AMERICANS WITH DISABILITY ACT (ADA) FACILITY ASSESSMENT REPORT

Americans with Disabilities Act (ADA) Facility Barrier Report

For Selected Park Sites

July 2024

Pat Pfeifer Park

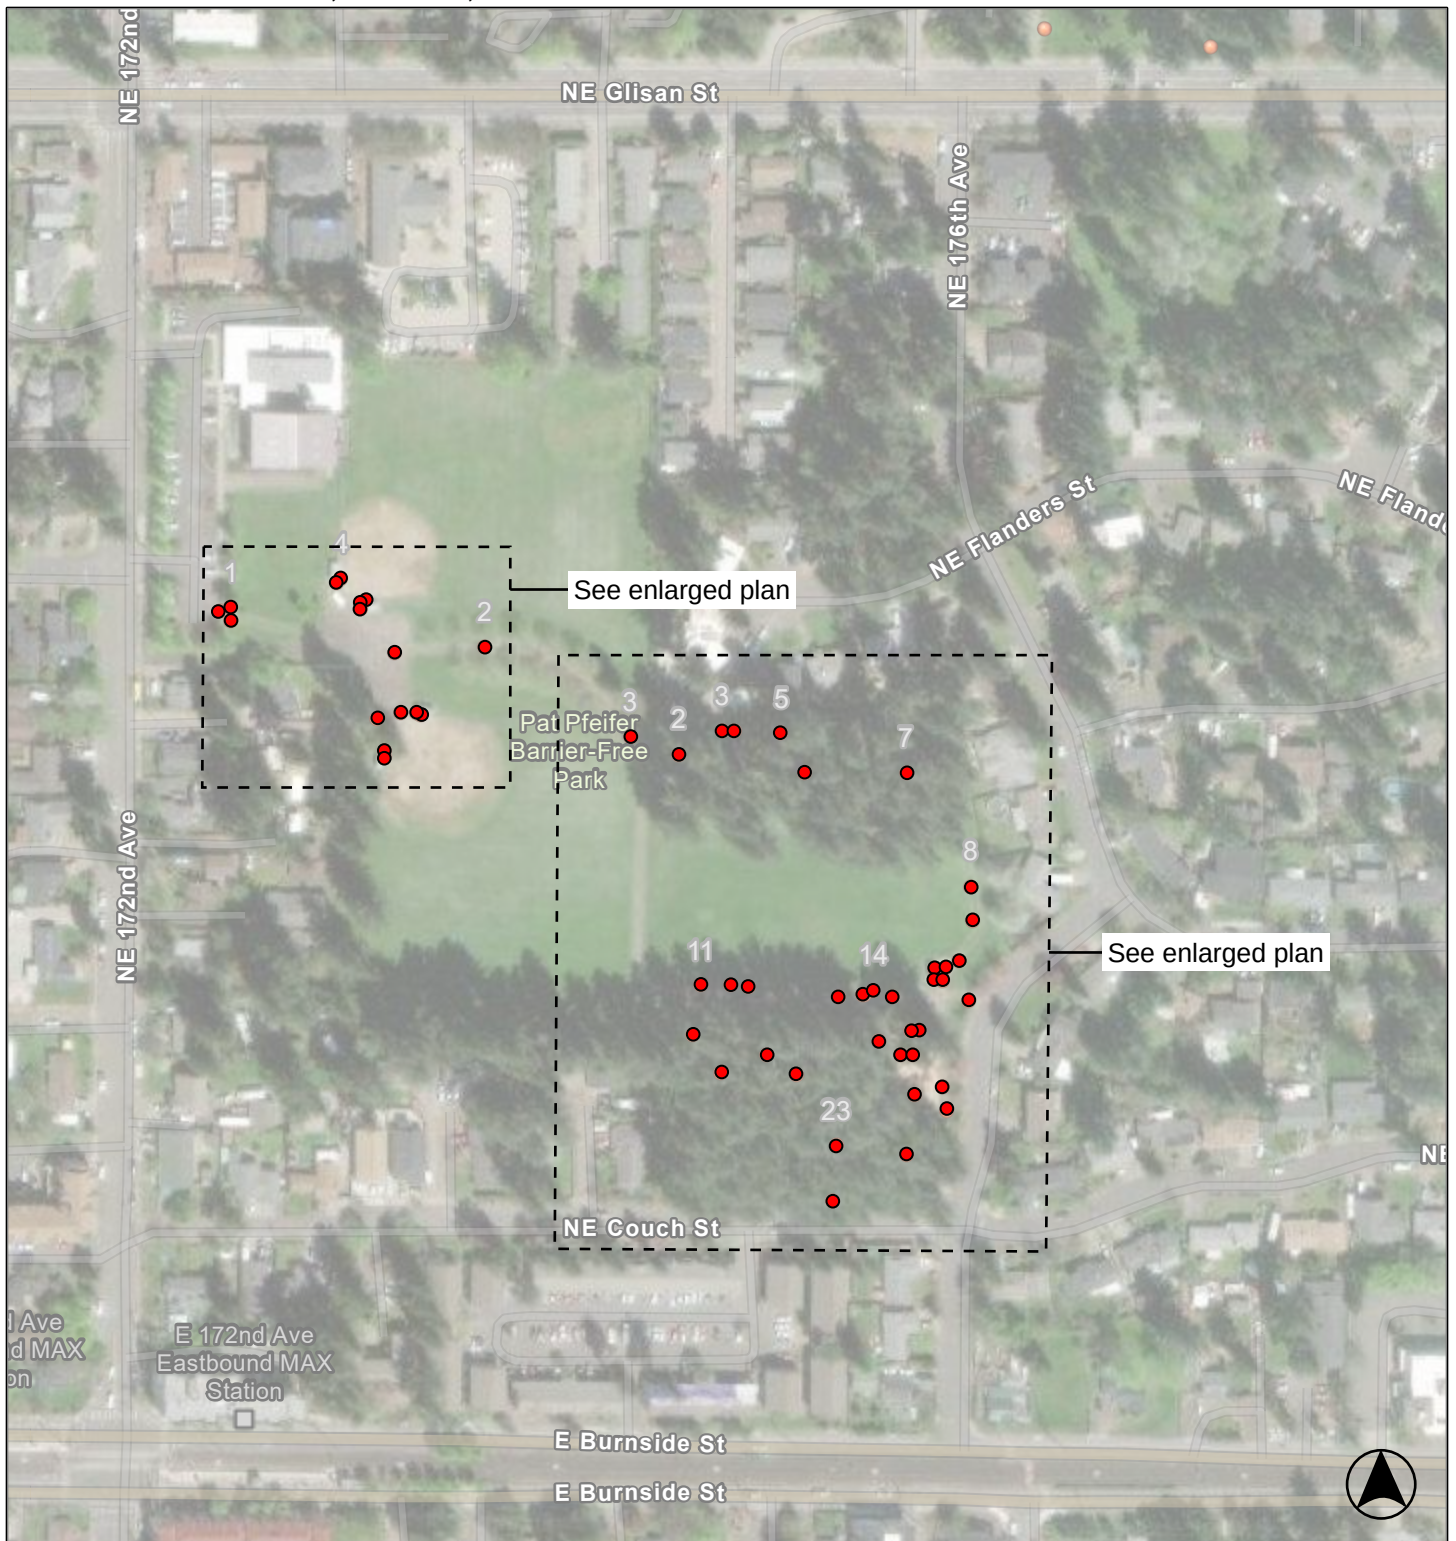
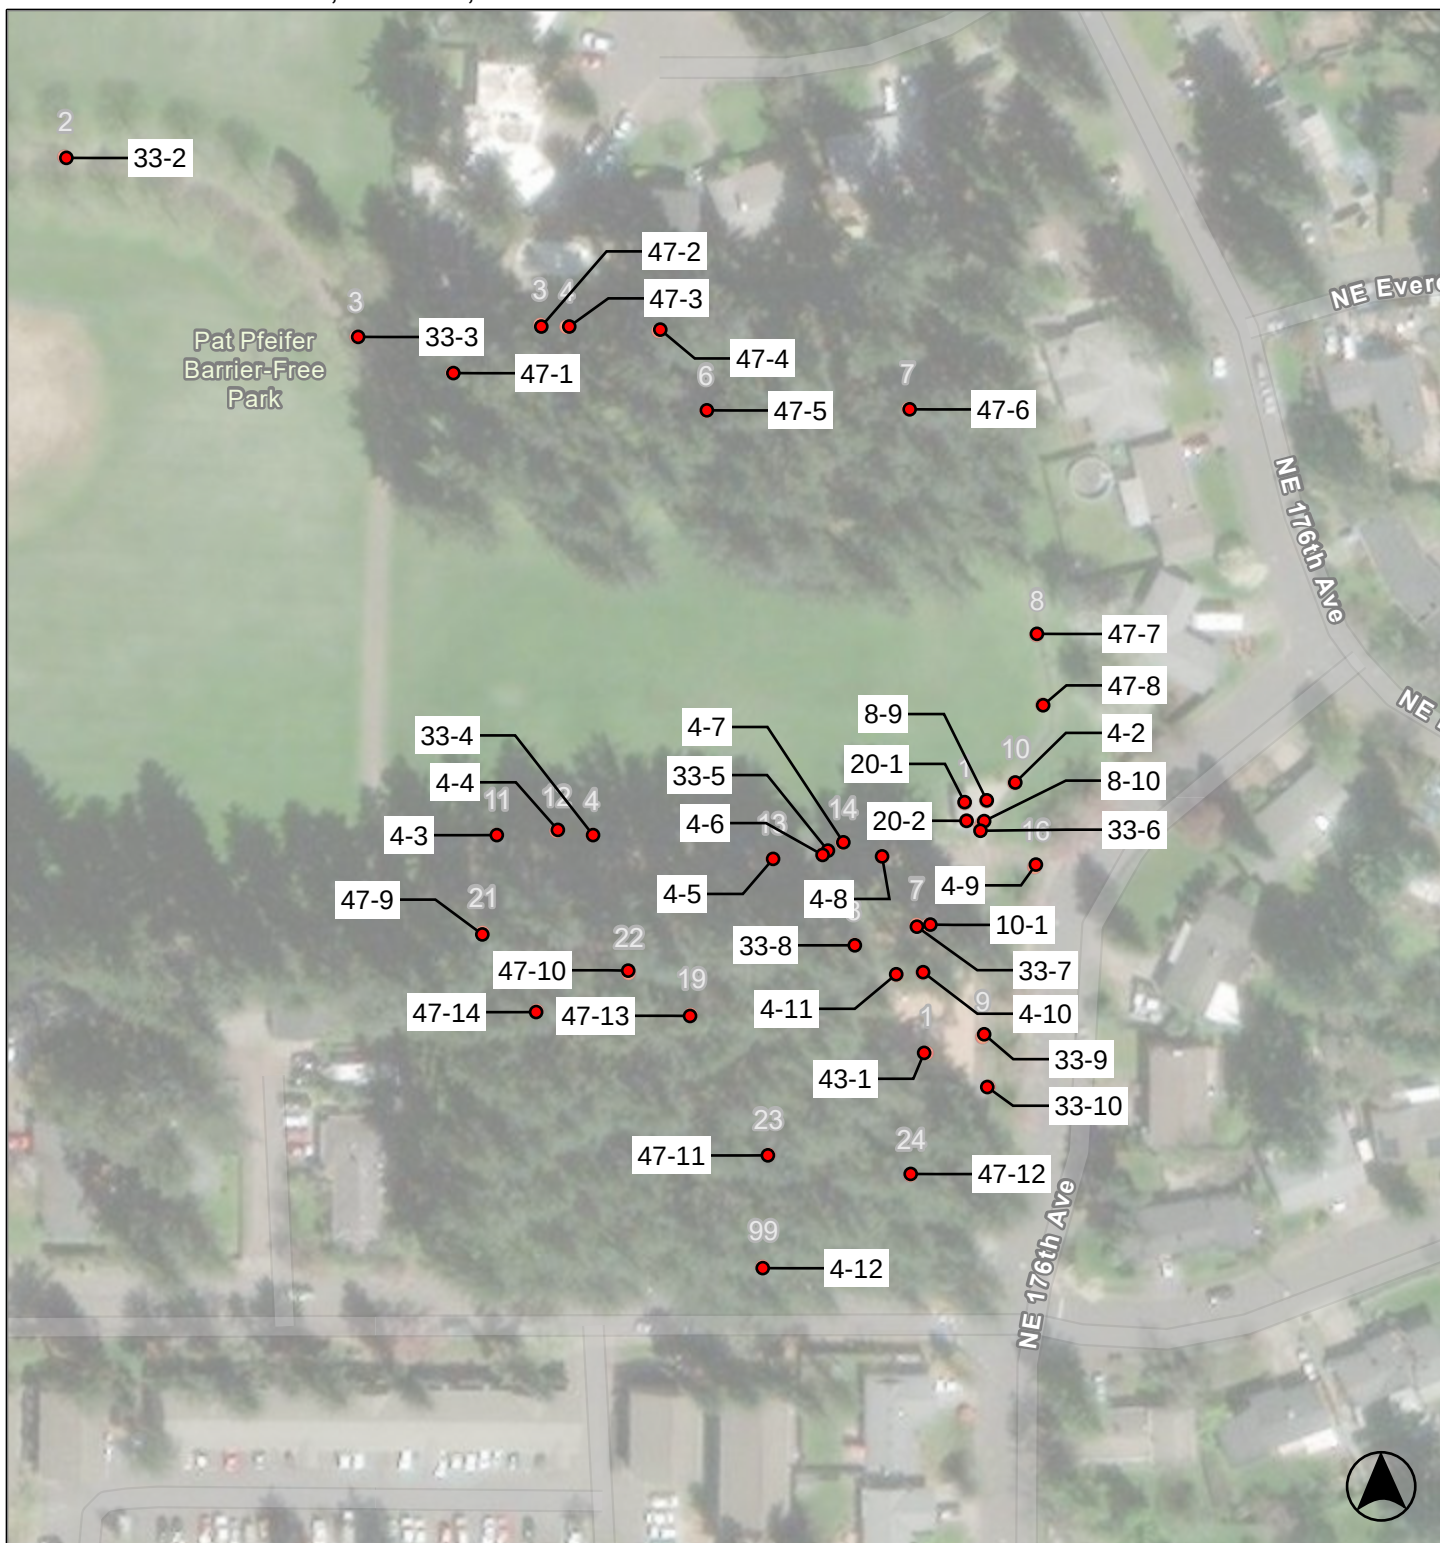
Park		
1 - 1	Parking Area	Category: 1
Regrade accessible parking space or access aisle		\$4,050
Notes: Slopes of accessible parking space and access aisle are up to 6.2% (2.0% max).		
ADA: 502.4		
Other: -		
Provide adequate striping		\$180
Notes: The words "No Parking" are not painted in the access aisle.		
ADA: -		
Other: OSSC 1106.7		
Reduce or eliminate opening		\$300
Notes: Surface of parking area has opening greater than 1/2" due to stormwater drain grate (Max 1/2" openings permitted).		
ADA: 302.3		
Other: -		
Install van accessible sign		\$1,750
Notes: A "Van Accessible" sign is not provided ("Van Accessible" sign that is 18" wide by 9" high on a white retroreflective background and green retroreflective lettering provided at each van accessible space).		
ADA: 208.2.4, 502.6		
Other: OSSC 1106.7		
Provide a pavement stencil		\$310
Notes: Paint is not retroreflective and is fading.		
ADA: -		
Other: OSSC 1106.7

Park		
4 - 2	Walk	Category: 1
Regrade surface		\$2,800
Notes: Cross slope of concrete path is up to 5.2% for 28 linear feet (2.0% max).		
ADA: 403.3		
Other: -		
4 - 3	Walk	Category: 1
Grind or patch vertical change of grade		\$100
Notes: Surface level change is 1/2" due to loose bricks (1/4" max; up to 1/2" with a 1:2 bevel).		
ADA: 303.2, 303.3		
Other: -		
4 - 4	Walk	Category: 1
Regrade surface		\$4,000
Notes: Cross slope of concrete path is up to 4.5% for 40 linear feet (2.0% max).		
ADA: 403.3		
Other: -		
4 - 5	Walk	Category: 1
Grind or patch vertical change of grade		\$100
Notes: Surface level change is 1/2" due to loose bricks (1/4" max; up to 1/2" with a 1:2 bevel).		
ADA: 303.2, 303.3		
Other: -		
4 - 6	Walk	Category: 1
Grind or patch vertical change of grade		\$100
Notes: Surface level change is 1/2" due to loose bricks (1/4" max; up to 1/2" with a 1:2 bevel).		
ADA: 303.2, 303.3		
Other: -		
4 - 7	Walk	Category: 1

Grind or patch vertical change of grade		\$100
Notes: Surface level change is 1/2" due to loose bricks (1/4" max; up to 1/2" with a 1:2 bevel).		
ADA: 303.2, 303.3		
Other: -

Park		
4 - 12	Walk	Category: 1
Regrade surface		\$25,200
Notes: Running slope of concrete is up to 10.8% for 12 linear feet (5.0% max).		
Cross slope of concrete is up to 7.5% for 240 linear feet (2.0% max).		
ADA: 403.3		
Other: -		
Grind or patch vertical change of grade		\$500
Notes: Surface level change is 3/4" at concrete joint (1/4" max; up to 1/2" with a 1:2 bevel). (x5)		
ADA: 303.2, 303.3		
Other: -		
Reduce or eliminate opening		\$900
Notes: Gap at concrete joint is 1-1/2" (1/2" max).(x3)		
ADA: 302.3		
Other: -		
8 - 1	Door/Gate	Category: 1
Provide or modify door kick plate		\$350
Notes: A smooth and uninterrupted kick plate surface is not provided. Chain-link is located in the 10" space above the finish floor.		
ADA: 404.2.10		
Other: -		
Increase or provide clear floor space		\$1,270
Notes: An exterior landing is not provided at the gate (30" by 48" min).		
ADA: 305.2, 305.3, 305.5		
Other: -		
8 - 2	Door/Gate	Category: 1

Provide or modify door kick plate		\$350
Notes: A smooth and uninterrupted kick plate surface is not provided. Chain-link is located in the 10" space above the finish floor.		
ADA: 404.2.10		
Other: -		
Increase or provide clear floor space		\$1,270
Notes: An exterior landing is not provided at the gate (30" by 48" min).		
ADA: 305.2, 305.3, 305.5		
Other: -

Park		
8 - 3	Door/Gate	Category: 1
Provide or modify door kick plate		\$350
Notes: A smooth and uninterrupted kick plate surface is not provided. Chain-link is located in the 10" space above the finish floor.		
ADA: 404.2.10		
Other: -		
Replace or modify door threshold		\$160
Notes:		
ADA: 404.2.5		
Other: -		
8 - 4	Door/Gate	Category: 1
Provide or modify door kick plate		\$350
Notes: A smooth and uninterrupted kick plate surface is not provided. Chain-link is located in the 10" space above the finish floor.		
ADA: 404.2.10		
Other: -		
Replace or modify door threshold		\$160
Notes: Transition onto ballfield surface has a vertical drop greater than 1/2" (max 1/4" vertical or 1/2" with 1:2 bevel).		
ADA: 404.2.5		
Other: -		
8 - 5	Door/Gate	Category: 1
Provide or modify door kick plate		\$350
Notes: A smooth and uninterrupted kick plate surface is not provided. Chain-link is located in the 10" space above the finish floor.

ADA: 404.2.10		
Other: -		
Increase or provide clear floor space		\$1,270
Notes: An exterior landing is not provided at the gate (30" by 48" min).		
ADA: 305.2, 305.3, 305.5		
Other: -

Park		
8 - 6	Door/Gate	Category: 1
Provide or modify door kick plate		\$350
Notes: A smooth and uninterrupted kick plate surface is not provided. Chain-link is located in the 10" space above the finish floor.		
ADA: 404.2.10		
Other: -		
Replace or modify door threshold		\$160
Notes: Transition onto ballfield surface has a vertical drop greater than 1/2" (max 1/4" vertical or 1/2" with 1:2 bevel).		
ADA: 404.2.5		
Other: -		
8 - 7	Door/Gate	Category: 1
Provide or modify door kick plate		\$350
Notes: A smooth and uninterrupted kick plate surface is not provided. Chain-link is located in the 10" space above the finish floor.		
ADA: 404.2.10		
Other: -		
Increase or provide clear floor space		\$1,270
Notes: An exterior landing is not provided at the gate (30" by 48" min).		
ADA: 305.2, 305.3, 305.5		
Other: -		
8 - 8	Door/Gate	Category: 1
Provide or modify door kick plate		\$350
Notes: A smooth and uninterrupted kick plate surface is not provided. Chain-link is located in the 10" space above the finish floor.

ADA: 404.2.10		
Other: -		
Replace or modify door threshold		\$160
Notes: Transition onto ballfield surface has a vertical drop greater than 1/2" (max 1/4" vertical or 1/2" with 1:2 bevel).		
ADA: 404.2.5		
Other: -

Park		
8 - 9	Door/Gate	Category: 1
Replace or modify door threshold		\$160
Notes: Threshold is not beveled (1/4" max; up to 1/2" with a 1:2 bevel).		
ADA: 404.2.5		
Other: -		
Adjust door closer		\$160
Notes: Door closer sweep time is less than the five second minimum from 90 degrees to 12 degrees.		
Door opening force is 6 lbs (5 lbs max).		
ADA: 404.2.8.1, 404.2.9		
Other: OSSC 1102.1.2.5		
Regrade surface		\$625
Notes: Slope of the exterior landing is 5.6% (2.0% max).		
ADA: 404.2.4.4		
Other: -		
8 - 10	Door/Gate	Category: 1
Adjust door closer		\$160
Notes: Door closer sweep time is less than the five second minimum from 90 degrees to 12 degrees.		
ADA: 404.2.8.1		
Other: -		
Regrade surface		\$625
Notes: Slope of the exterior landing is 9.1% (2.0% max).		
ADA: 404.2.4.4		
Other: -		
10 - 1	Drinking Fountain	Category: 3
Confirm water flow compliance		\$0
Notes: Water service to the drinking fountain was disconnected at the time of the assessment. Flow height and angle could not be confirmed.

Park		
20 - 1	Single User Restroom	Category: 2
Install restroom sign		\$250
Notes: Replace sign - the tactile elements are broken, the braille is not located beneath the letters. The word "restroom" is not tactile.		
ADA: 216.8		
Other: -		
Replace or reposition mirror		\$160
Notes: Bottom of the mirror's reflecting surface above the lavatory is 40-1/4" AFF (40" max).		
ADA: 603.3		
Other: -		
Increase water closet clear width or depth		\$840
Notes: Clear width over water closet is 59" (60" min) to the side wall.		
ADA: 604.3.1, 604.8.1		
Other: -		
Replace or reposition fixtures		\$1,590
Notes: The water closet centerline is 18-1/2" from the wall (16" min to 18" max).		
ADA: 604.2		
Other: -		
Modify operating mechanism		\$320
Notes: Operating effort of the soap dispenser is 6 lbs (5 lbs max).		
ADA: 309.4		
Other: -		
Confirm water flow compliance		\$0
Notes: Water service to the lavatory was disconnected at the time of the assessment. Force to operate and water metering could not be confirmed.

Park		
20 - 2	Single User Restroom	Category: 2
Install restroom sign		\$250
Notes: Replace sign - the tactile elements are broken, the braille is not located beneath the letters. The word "restroom" is not tactile.		
ADA: 216.8		
Other: -		
Modify operating mechanism		\$640
Notes: Operating effort of soap dispenser is 8 lbs (5 lbs max).		
ADA: 309.4		
Other: -		
Replace or reposition fixtures		\$1,590
Notes: The water closet centerline is 18-1/2" from the wall (16" min to 18" max).		
ADA: 604.2		
Other: -		
Replace or adjust water controls		\$640
Notes: Operating effort of lavatory faucet is 6 lbs (5 lbs max).		
ADA: 309.4, 606.4		
Other: -		
29 - 1	Game and Sports Area	Category: 2
Provide an accessible route		\$3,200
Notes: An accessible route to the baseball area is not provided. Route from the path to the baseball is 40 linear feet over grass.		
ADA: 206.2.2		
Other: -		
Provide wheelchair seating		\$1,800
Notes: Wheelchair seating is not provided. (2 wheelchair spaces min for 40 seats).

ADA: 221.2.1.1		
Other: -		
29 - 2	Game and Sports Area	Category: 2
Provide an accessible route		\$3,200
Notes: An accessible route to the baseball area is not provided. Route from the path to the baseball is 40 linear feet over grass.		
ADA: 206.2.2		
Other: -		
Provide wheelchair seating		\$1,800
Notes: Wheelchair seating is not provided. (2 wheelchair spaces min for 40 seats).		
ADA: 221.2.1.1		
Other: -

Park		
33 - 2	Outdoor Constructed Features	Category: 3
Increase or provide clear floor area		\$600
Notes: A clear ground space is not provided adjacent to the bench (36" by 48" min). (x3)		
ADA: -		
Other: ABA 1011.2.1, ABA 1011.2.3		
33 - 3	Outdoor Constructed Features	Category: 3
Increase or provide clear floor area		\$200
Notes: A clear floor space is not provided at the trash container opening (36" by 60" min parallel approach or 36" by 48" min forward approach). Container is 42" from the path.		
ADA: -		
Other: ABA 1011.2		
33 - 4	Outdoor Constructed Features	Category: 3
Increase or provide clear floor area		\$400
Notes: A clear ground space is not provided adjacent to the bench (36" by 48" min). (x2)		
ADA: -		
Other: ABA 1011.2.1, ABA 1011.2.3		
33 - 5	Outdoor Constructed Features	Category: 3
Increase or provide clear floor area		\$200
Notes: A clear floor space is not provided at the trash container opening (36" by 60" min parallel approach or 36" by 48" min forward approach). Container is 40" from the path.

ADA: -		
Other: ABA 1011.2		
33 - 6	Outdoor Constructed Features	Category: 3
Increase or provide clear floor area		\$200
Notes: Clear ground space adjacent to the trash can has a slope of 7.4% (2.0% max).		
ADA: -		
Other: ABA 1011.2		
33 - 7	Outdoor Constructed Features	Category: 3
Increase or provide clear floor area		\$200
Notes: A clear floor space is not provided at the trash container opening (36" by 60" min parallel approach or 36" by 48" min forward approach). Broken and uneven pavement in the clear floor space.		
ADA: -		
Other: ABA 1011.2.1, ABA 1011.2.3

Park		
33 - 8	Outdoor Constructed Features	Category: 3
Increase or provide clear floor area		\$200
Notes: A clear ground space is not provided adjacent to the bench (36" by 48" min). The surface is gravel.		
ADA: -		
Other: ABA 1011.2.1, ABA 1011.2.3		
33 - 9	Outdoor Constructed Features	Category: 3
Increase or provide clear floor area		\$200
Notes: A clear ground space is not provided adjacent to the bench (36" by 48" min).		
ADA: -		
Other: ABA 1011.2.1, ABA 1011.2.3		
33 - 10	Outdoor Constructed Features	Category: 3
Increase or provide clear floor area		\$200
Notes: A clear floor space is not provided at the trash container opening (36" by 60" min parallel approach or 36" by 48" min forward approach). Container is 37" from the path.		
ADA: -		
Other: ABA 1011.2		
33 - 11	Outdoor Constructed Features	Category: 3
Increase or provide clear floor area		\$200
Notes: A clear floor space is not provided at the trash container opening (36" by 60" min parallel approach or 36" by 48" min forward approach). Container is 42" from the path.

ADA: -		
Other: ABA 1011.2		
35 - 1	Other	Category: 3
Increase or provide maneuvering or clear floor area		\$200
Notes: Slope of the dog bag station clear floor space is 3.1% (2.0% max).Pavers are loose and uneven.		
ADA: 305.2, 305.3, 305.5		
Other: -

Park		
47 - 1	Trails	Category: 2
Regrade surface		\$840
Notes: Cross slope of path is up to 3.9% for 14 linear feet (2.0% max).		
ADA: -		
Other: ABA 1017.7.2		
Install sign		\$250
Notes: Provide trail sign including length of the trail or trail segment, surface type, typical an dminimum tread width, typical and maximum running slope, and typical and maximum cross slope.		
ADA: -		
Other: ABA 1017.10		
47 - 2	Trails	Category: 2
Regrade surface		\$600
Notes: Cross slope of path is up to 4.0% for 10 linear feet (2.0% max).		
ADA: -		
Other: ABA 1017.7.2		
47 - 3	Trails	Category: 2
Regrade surface		\$600
Notes: Cross slope of path is up to 3.8% for 10 linear feet (2.0% max).		
ADA: -		
Other: ABA 1017.7.2		
Reduce or eliminate opening		\$300
Notes: Gap at crack in surface is greater than 1/2" (1/2" max).		
ADA: 302.3		
Other: ABA 1017.6		
47 - 4	Trails	Category: 2
Regrade surface		\$2,280
Notes: Cross slope of path is up to 3.8% for 38 linear feet (2.0% max).

Notes: Provide trail sign including length of the trail or trail segment, surface type, typical minimum tread width, typical and maximum running slope, and typical and maximum cross slope.		
ADA: -		
Other: ABA 1017.10

Park		
47 - 9	Trails	Category: 2
Regrade surface		\$300
Notes: Run slope of path is up to 13.0% for 5 linear feet (12.0% max).		
ADA: -		
Other: ABA 1017.7.1		
Install sign		\$250
Notes: Provide trail sign including length of the trail or trail segment, surface type, typical and minimum tread width, typical and maximum running slope, and typical and maximum cross slope.		
ADA: -		
Other: ABA 1017.10		
47 - 10	Trails	Category: 2
Regrade surface		\$2,940
Notes: Cross slope of path is up to 5.0% for 49 linear feet (2.0% max).		
ADA: -		
Other: ABA 1017.7.2		
Reduce or eliminate opening		\$300
Notes: Gap at cracks is greater than 1/2" (1/2" max).		
ADA: 302.3		
Other: ABA 1017.6		
47 - 11	Trails	Category: 2
Regrade surface		\$2,400
Notes: Cross slope of path is up to 9.9% for 37 linear feet (2.0% max).		
ADA: -		
Other: ABA 1017.7.2		
47 - 12	Trails	Category: 2
Regrade surface		\$3,840
Notes: Cross slope of path is up to 8.5% for 64 linear feet (2.0% max).

ADA: -		
Other: ABA 1017.7.2		
Install sign		\$250
Notes: Provide trail sign including length of the trail or trail segment, surface type, typical and minimum tread width, typical and maximum running slope, and typical and maximum cross slope.		
ADA: -		
Other: ABA 1017.10
